ADDENDUM #2

CITY OF SPRINGFIELD, MISSOURI DIVISION OF PURCHASES INVITATION FOR BID (IFB) #013-2027 FOR:

LOST HILL PARK PEDESTRIAN CROSSING

Exhibit #3 – Revised Plan Sheets

SIDEWALK PLAN & DETAILS

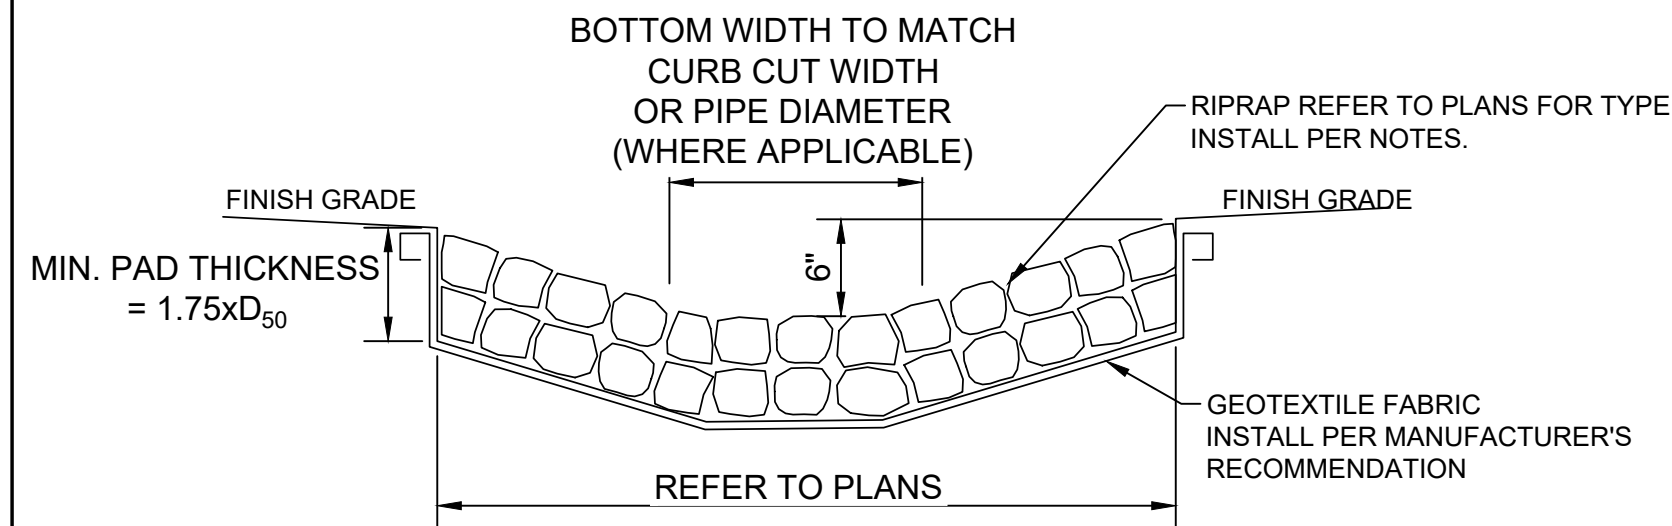
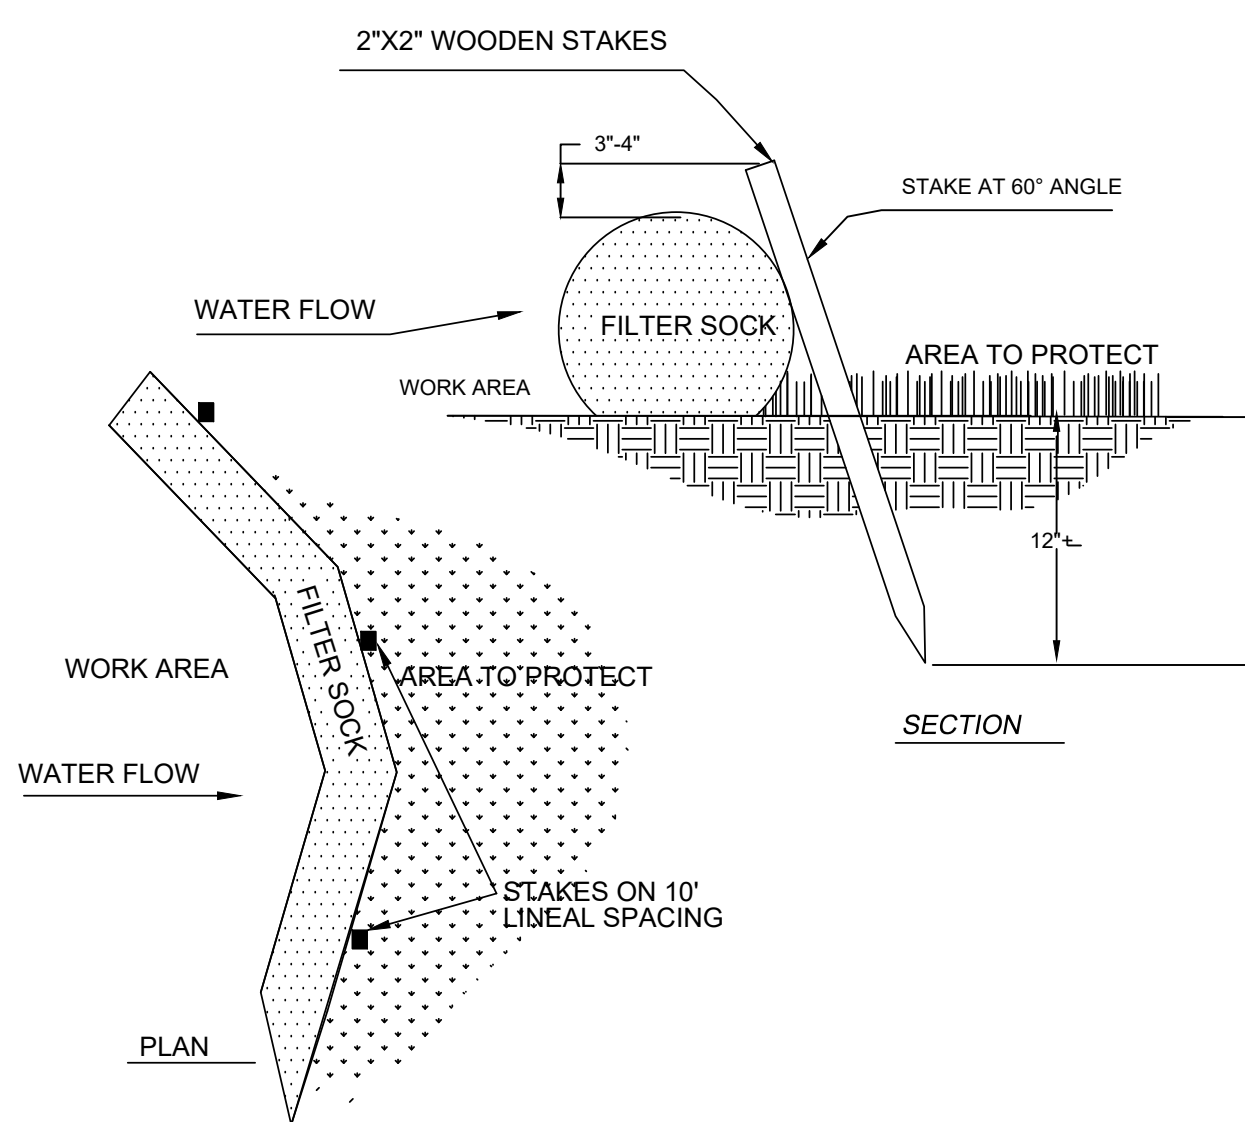
Answer: **The alignment of the trail and pedestrian crossing has been revised to be located outside of the assumed root zone of the existing sycamore tree. The revised alignment is intended to preserve the trees and avoid impacts to their roots. Refer to addendum #2 plan set dated 10/09/2026.**

1 NEW ALIGNMENT

Clarification: **Bid Schedule Items Updated due to realignment of trail and crossing:**
Bid Item 5: Type 1 or Type 5 Aggregate for Base (4-inch thick); 588.0 SY
Bid Item 6: Subgrade Compaction(6-inch depth)(95%): 4.3 STA
Bid Item 7: Concrete Sidewalk (4-inch thick w/ geotextile fabric): 490.8 SY

SHEET TITLE
LOW WATER
CROSSING PLAN
& PROFILE

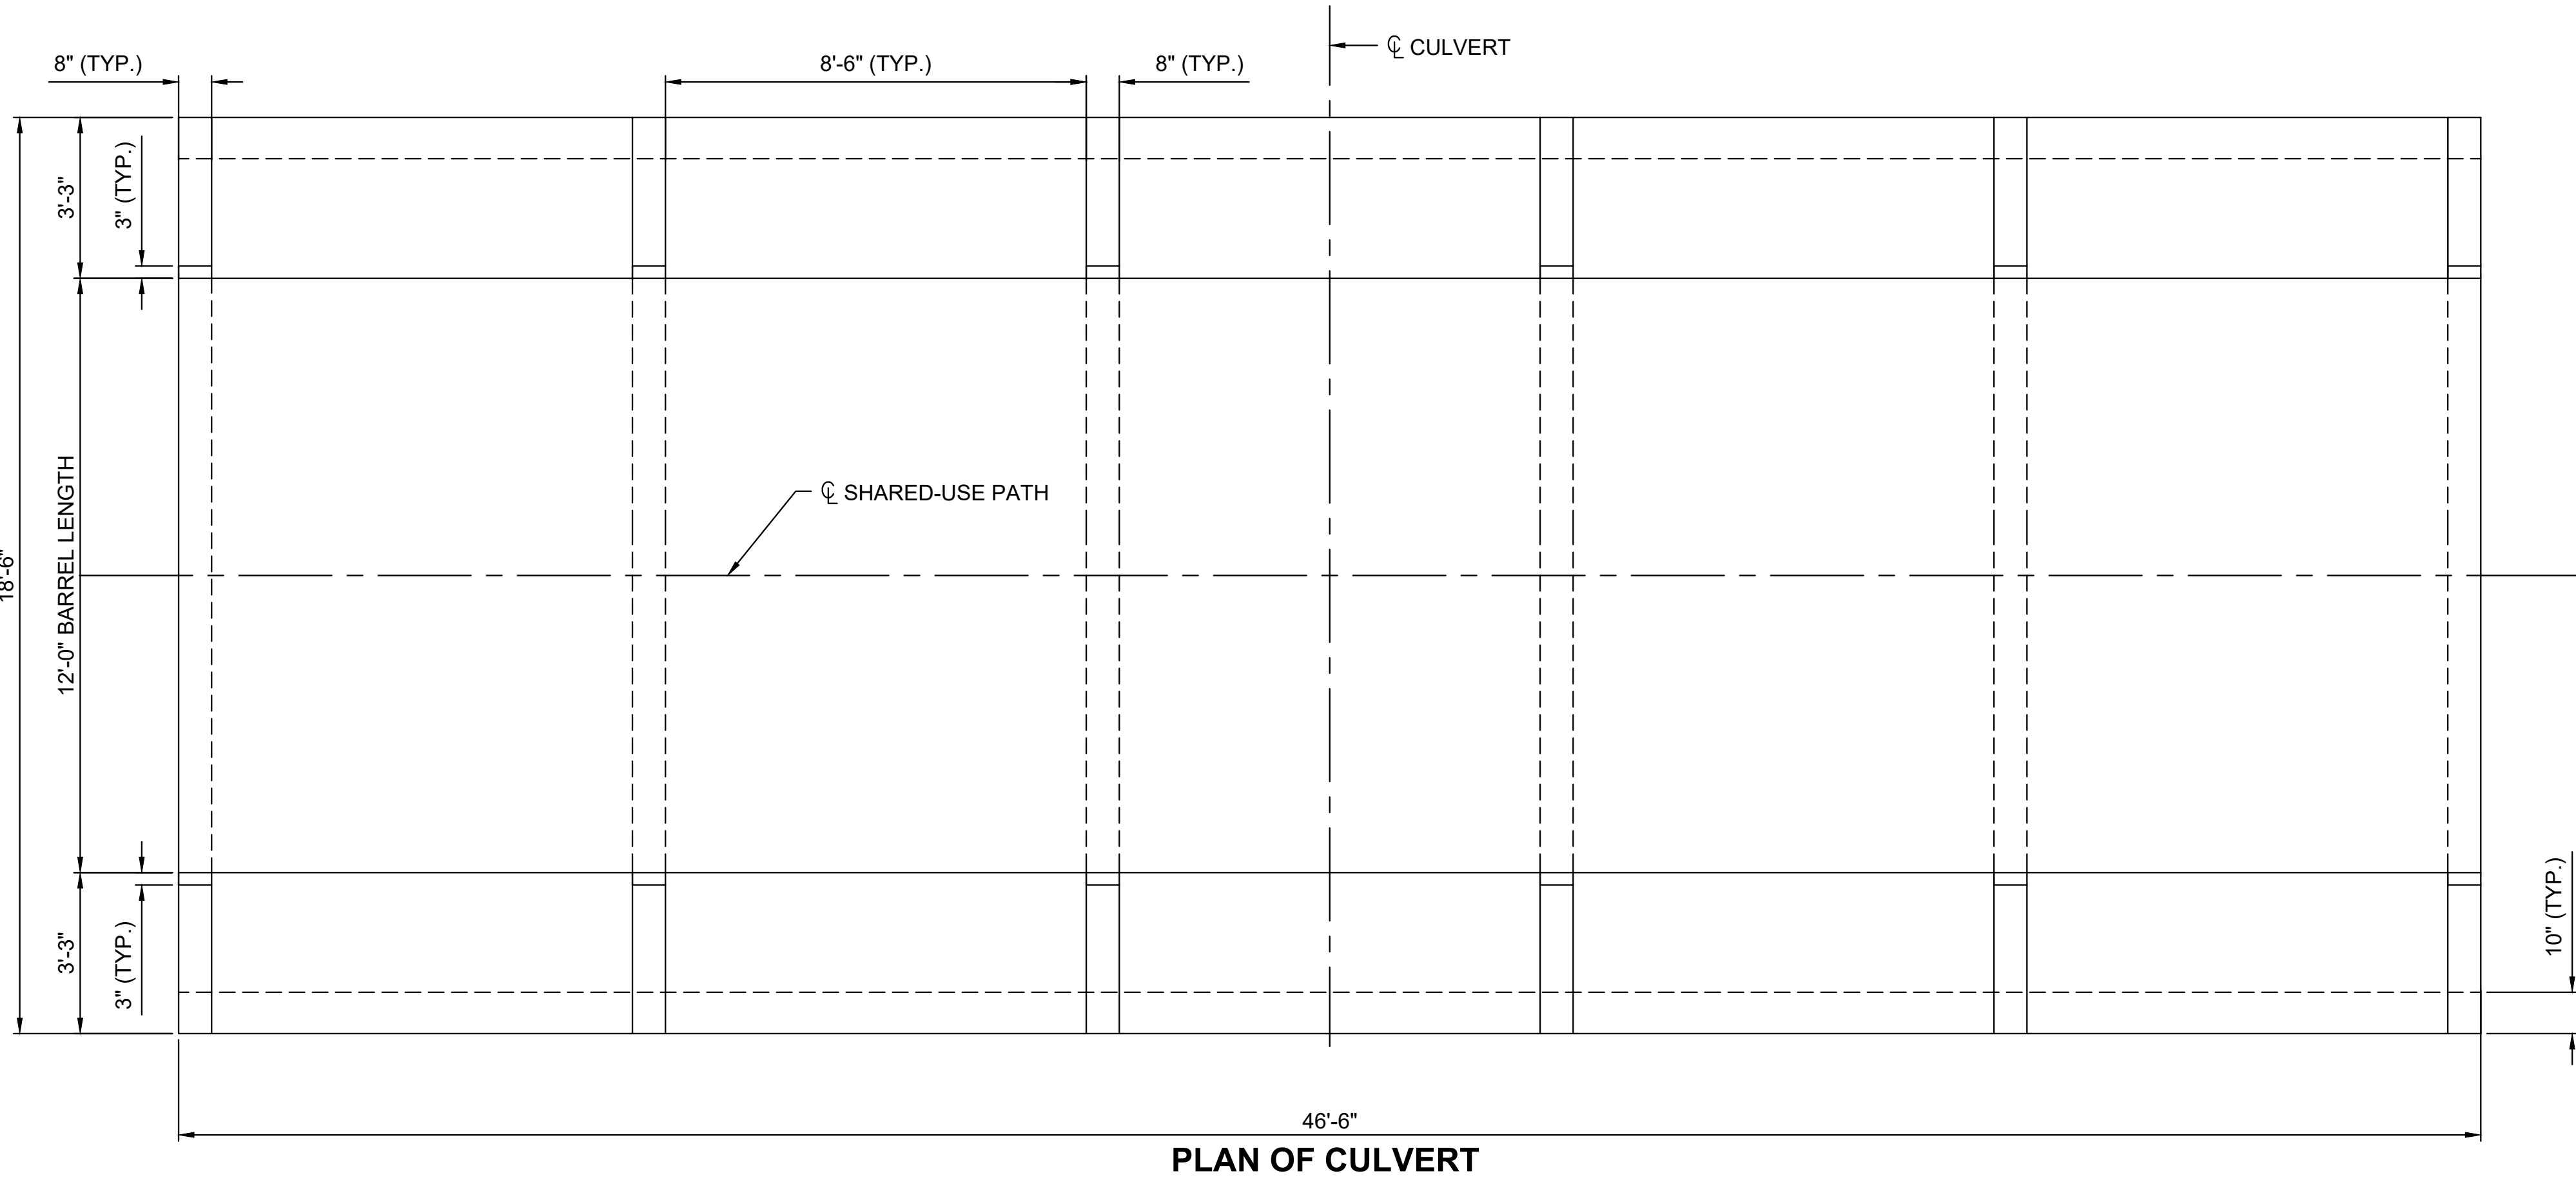
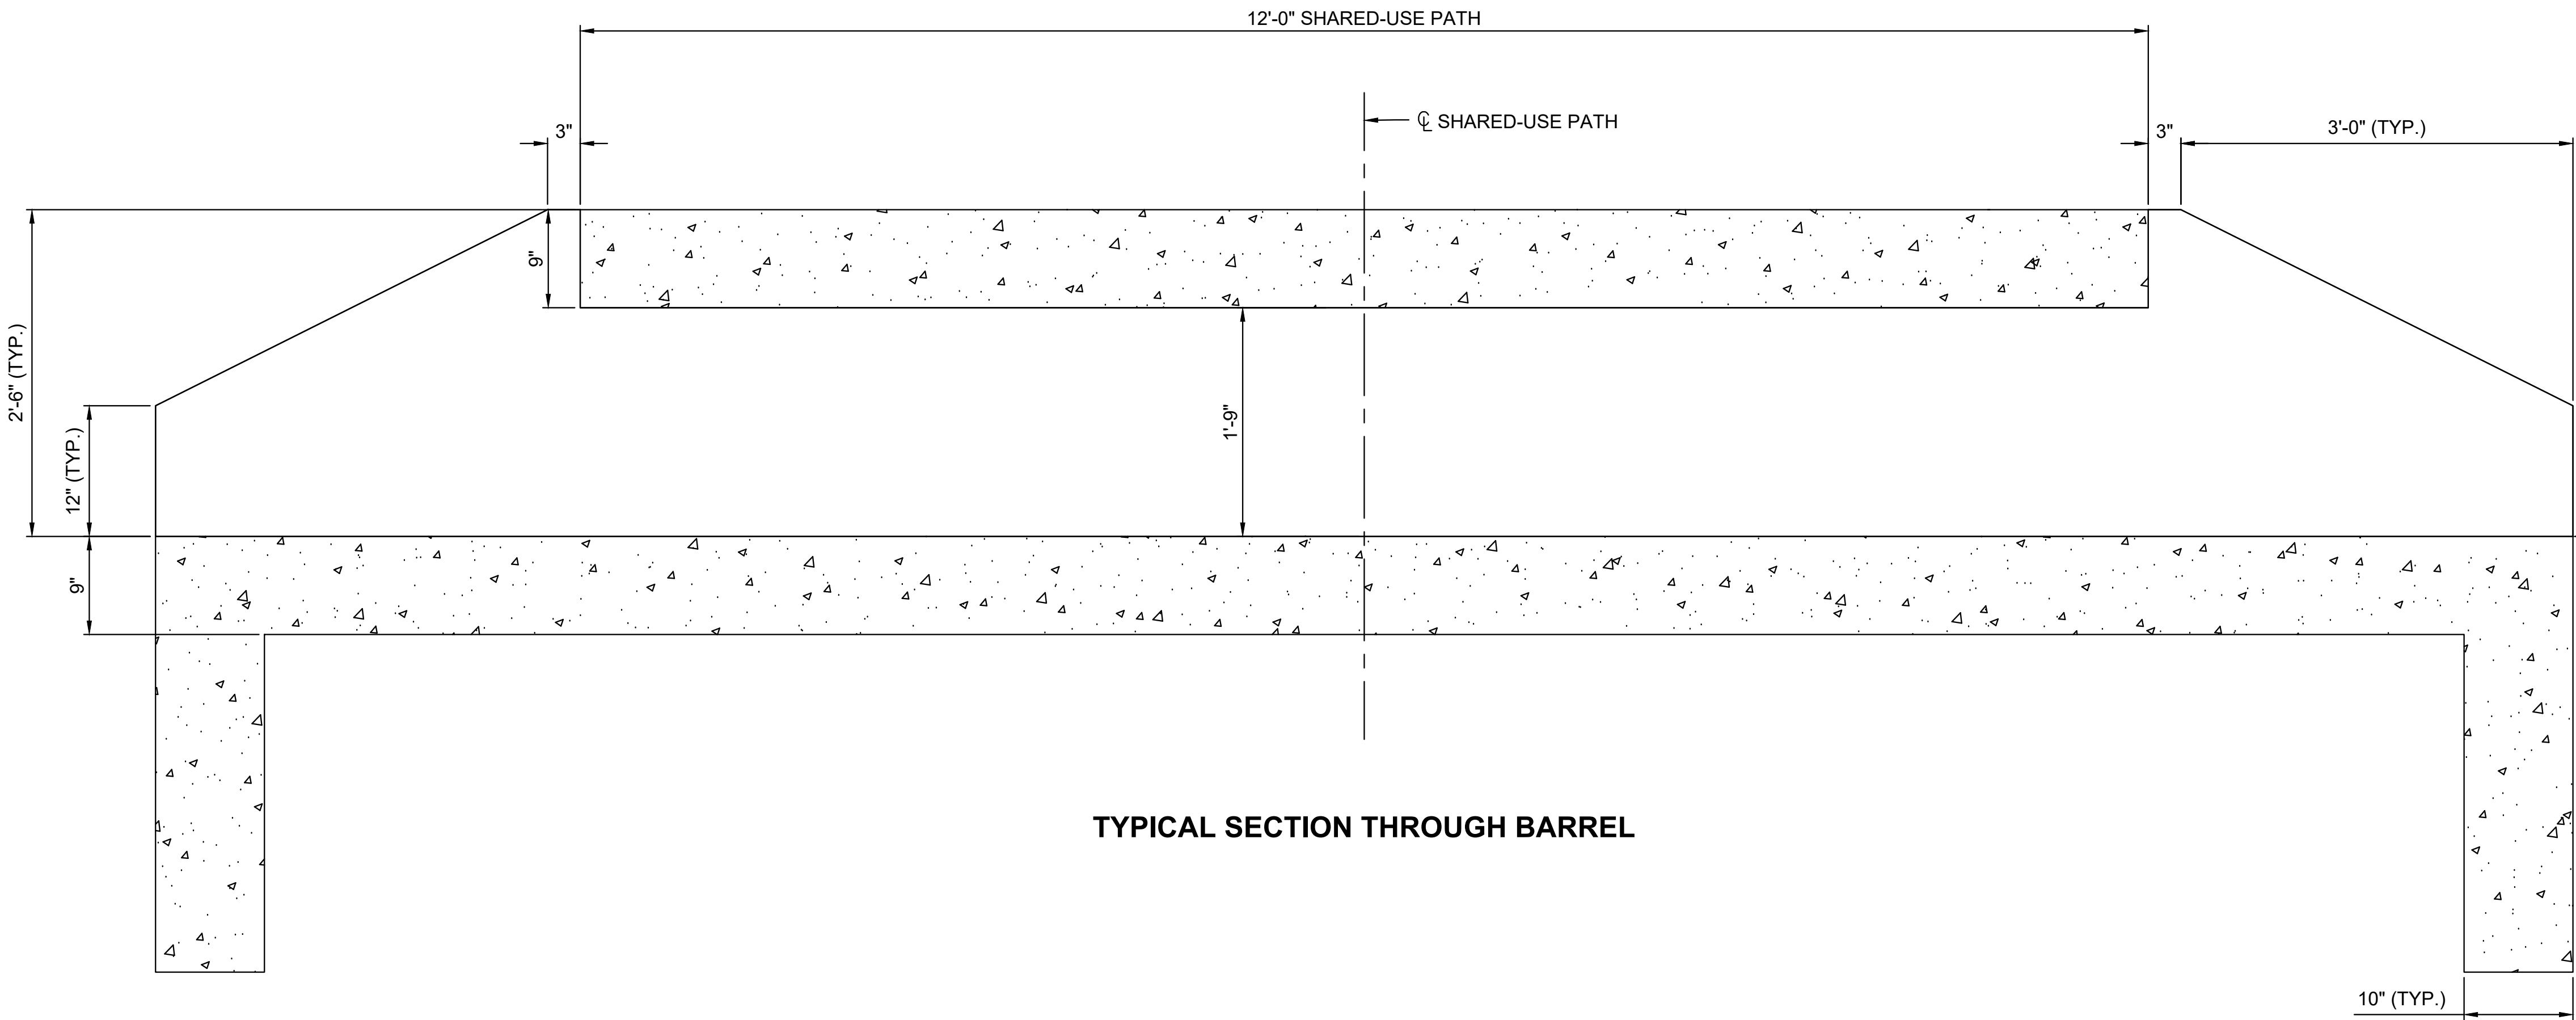
Question: *How deep does the footing portion of the lower slab extend into the ground?*

Question: *The bid form is showing 51 cuyd of Class 4 excavation and 51 cuyd of Concrete for the bridge area. Shouldn't there be more concrete than excavation as only the lower portion of the bridge will have excavation.*

Answer: **The footing depth of the bottom slab is 3' 4". However, if solid bedrock is encountered at a shallower depth the footing shall be keyed 1' into the bedrock.**

Answer: **The value of Class 4 excavation allows an additional 18" of excavation outside of the pedestrian crossing footprint to allow for formwork of the slab and footing.**
